Development Review Application  
 Planning Division Transmittal Form

**Application Number:** 2013-249                      **Application Date:** 11/05/2013  
**CBL:** 201 A005001                      **Application Type:** Plan Amendment - Staff Level III  
**Applicant:** Archetype /Hopkins William  
**Project Name:** Thompsons Point - Phase 1A  
**Address:** 1 THOMPSONS POINT  
**Project Description:** Modifications associated with the amended Site Plan Submission  
**Zoning:** B5/RPZ

**Subject:** Application ID: 2013-249

③ C.3.1 RW 12.4.13

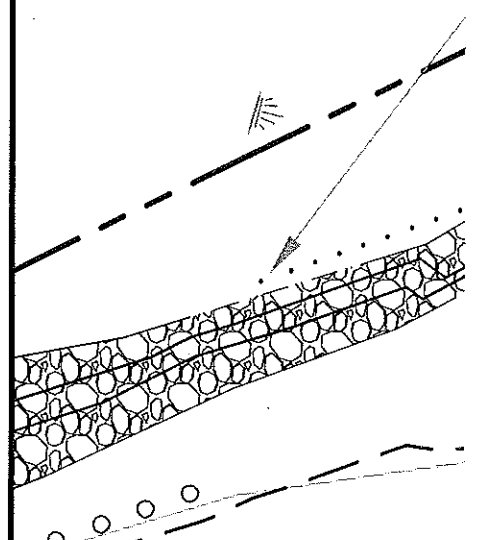
I have looked at the most recent submittals - revised 12/4/13 & uploaded to eplan on 12/9/13. The only thing that seems to have changed looking at the C-3.1 Site layout Plan is the parking area. The plan is now showing 61 parking spaces provided which matches the 61 shown as required. Other than that I don't see anything else having changed from Marge's comments submitted on 11/27/13. She mentioned submitting floor plans showing the uses and their floor area to back up the submitted information. We have not received floor plans yet.  
Ann Machado - Zoning Specialist

**SITE LAYOUT PLAN VIEW**  
1" = 30'

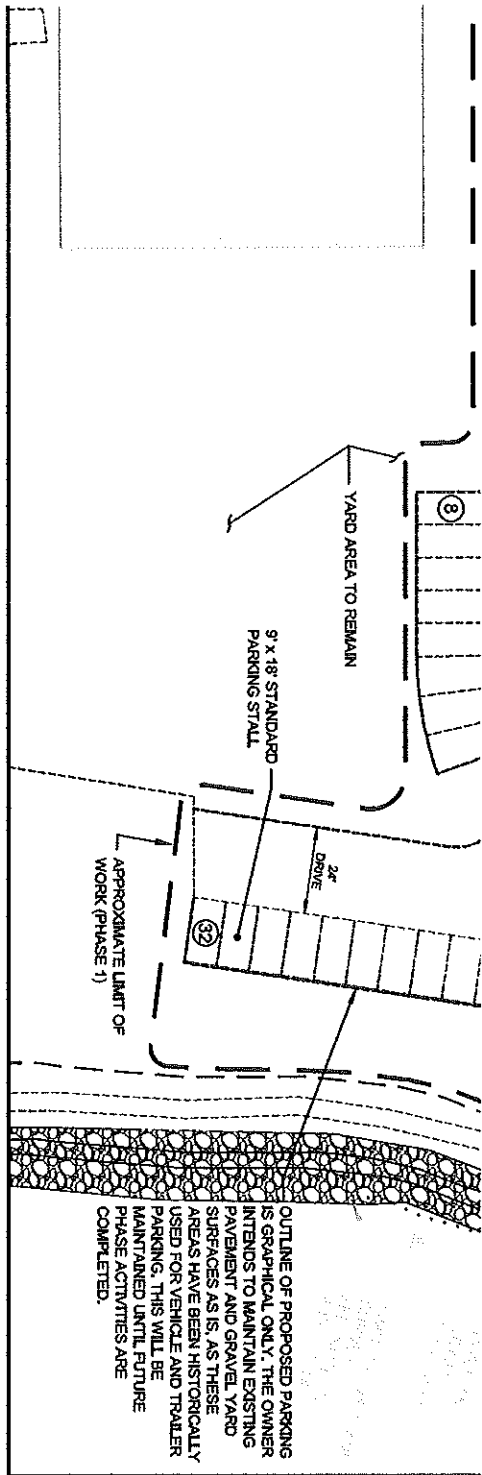
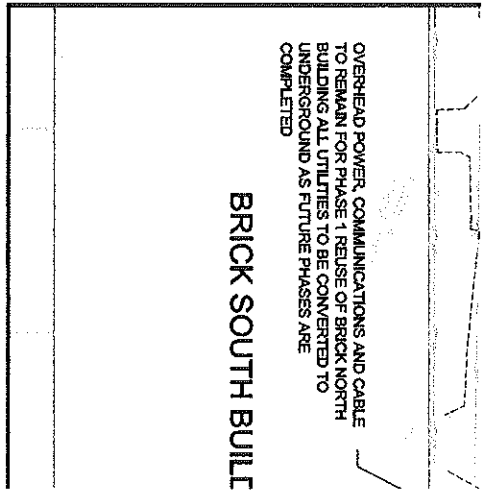
I have looked at the most recent proposal and the Site layout & utility plan. Based upon the provided information, it appears that this first building to be rehabbed as part of phase I will meet the parking demand. It would be helpful to back up the submitted information with floor plans showing the uses and their floor area. I am not sure that detailed information was submitted concerning the proposed phases and their time frames. It would help to review that information.

All setbacks on the existing building are being met. I am expecting more information for further reviews.
